Access Compliance Report Public Rights-of-Way (Curb Ramps)

Main Street: DORRANCE_DR		Cross Street: CLYDESDALE_DR		Location:	S
ADA ID: RPRK211110131711	Ramp Type: Type 4 - Parallel	Initial Pass/Fail: Fail	Overall Compliance: No	Severity Score:	32
Codes/Mitigation Info/Possible Solution			Field Measurements/Component Compliance

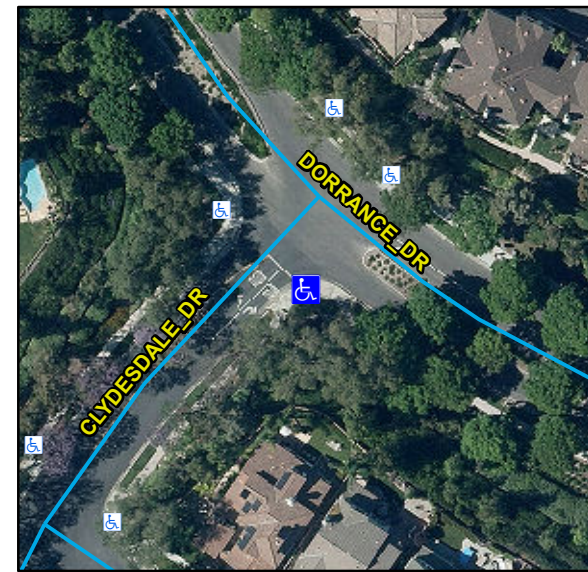
R204.3, R304.5.3, R304.3.2, STD 1115

Remove & Replace Curb Ramp With Two New Directional Ramps or Equivalent. Restripe Crosswalk.
